## CERTIFICATE OF APPROPRIATENESS

**Property:** 803 Kipling St, Lot 1 & 2, Block 19, Montrose Subdivision. The property includes an 8,400 square foot (70' x 120') corner lot.

**Proposal:** New Construction – Residence

Construct an approximately 4,000 square foot, two-story duplex with alley-loading garages. This project was deferred to allow the applicant to make alterations to the project at the January 28<sup>th</sup> HAHC meeting.

### EAST SIDE ELEVATION FACING STANFORD

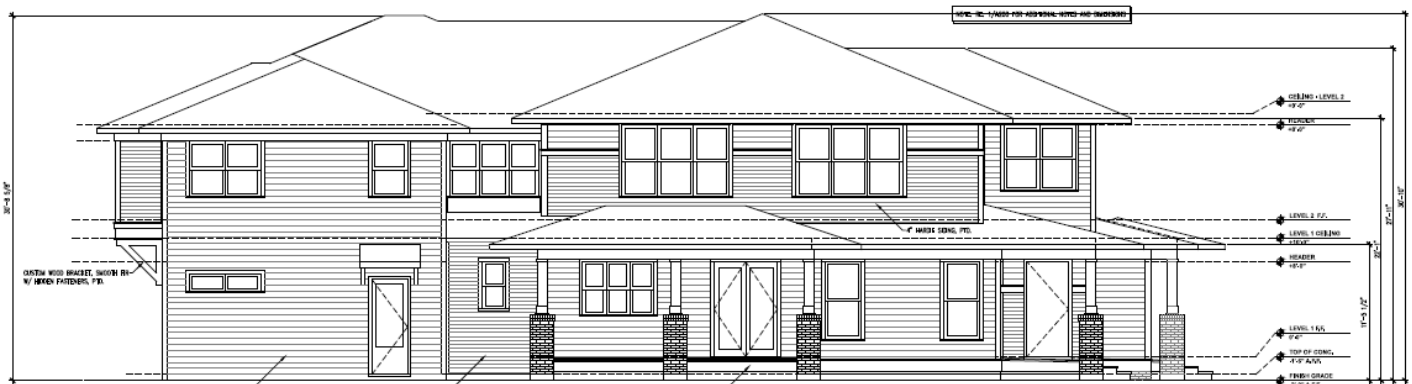
Of lesser importance perhaps, the east elevation seems rather bland and generic, and nothing resembling any of the historic houses in the area, to my eyes atleast. A far cry from what was originally there.

This would be towards Stanford street, which is the largest facade in square feet frontal area of the structure.

I understand that the address is not considered to be Stanford street, but nevertheless, its towards this street the structure makes the largest visual impact onto its surroundings.

**SITE PLAN**  
DEFERRED 1/28/2016

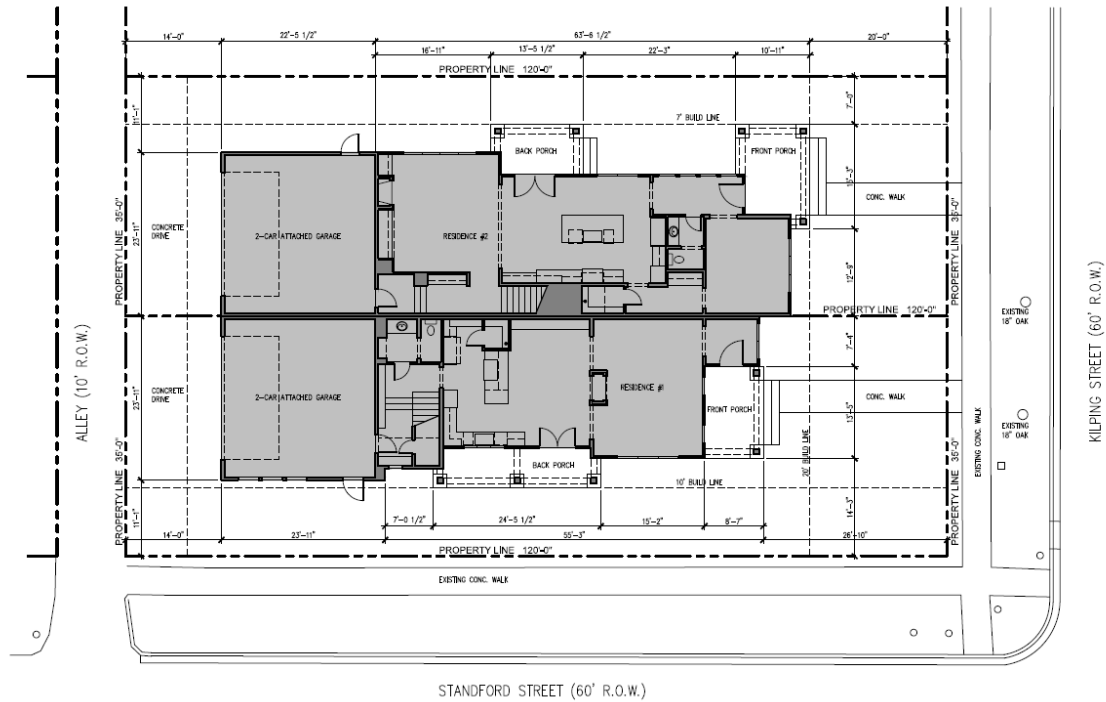
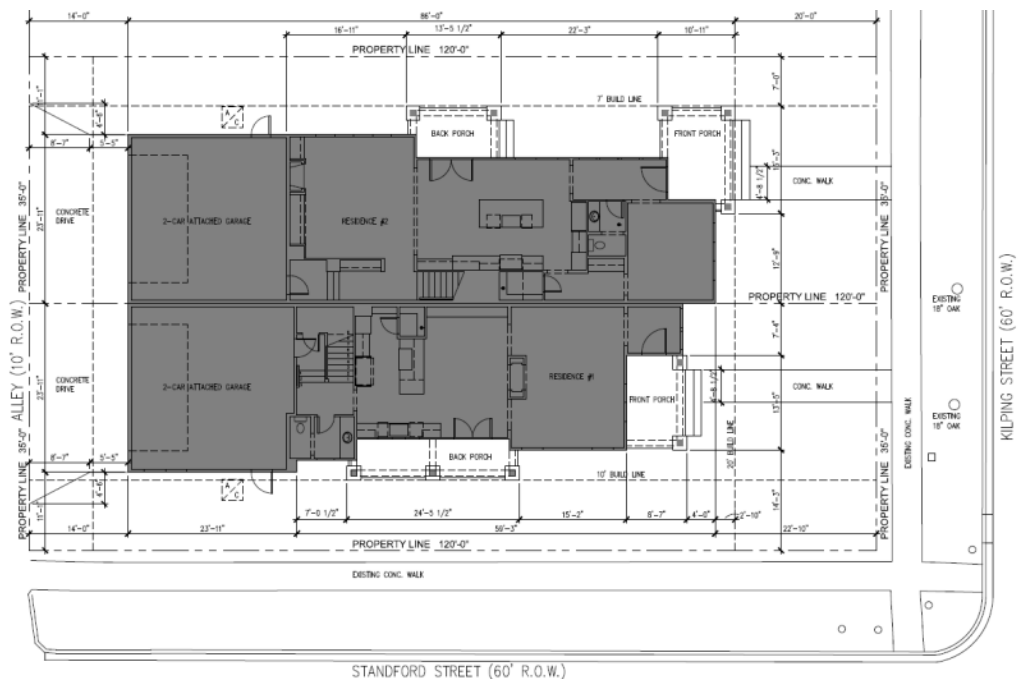
" Specifically, the alley loading of garages seems unnecessary, in an already strained and cramped access alley, especially when the lots have plenty land to accomodate other driveway solutions."

Additionally, the length of the driveway is just shy of the average lenght of a car, long enough to encourage parking in the driveway, but not without it sticking out into the ally. That will be a problem, as the ally is very cramped as is, where one have to navigate 2 electric poles for ingresss and egress.

Adding 4 more cars sticking into the ally will definitely not be a no impact solution as far as the neighbouring lots is concerned. That's externalizing a problem, or shift land usage from less used for the driveway, to more garden.

As one of several immediate neighbours, and users of this alley, I find this unacceptable, and would request a further setback to fully accomodate parking inside the driveway, to avoid ingress and egress problems of already established households.

As an alternative, other garage loading solutions could possibly be evaluated.
